MILITARY SPECIFICATION

SWITCH, TOGGLE, MINIATURE, LEVER-LOCK, FOUR POLE,
 UNSEALED, LOGIC LOAD TO 5 AMPERES

This amendment forms a part of MIL-S-83731/22B, dated 29 March 1991, and is approved for use by all Departments and Agencies of the Department of Defense.

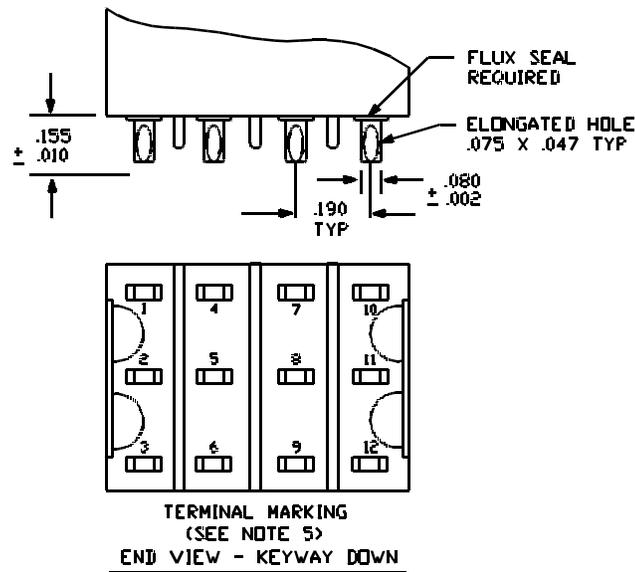
Figure 1 End View : Delete and substitute:

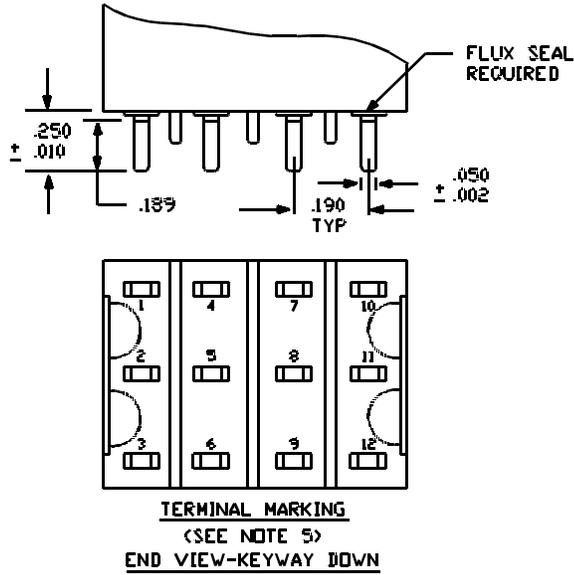
Figure 1 End View : Delete and substitute:
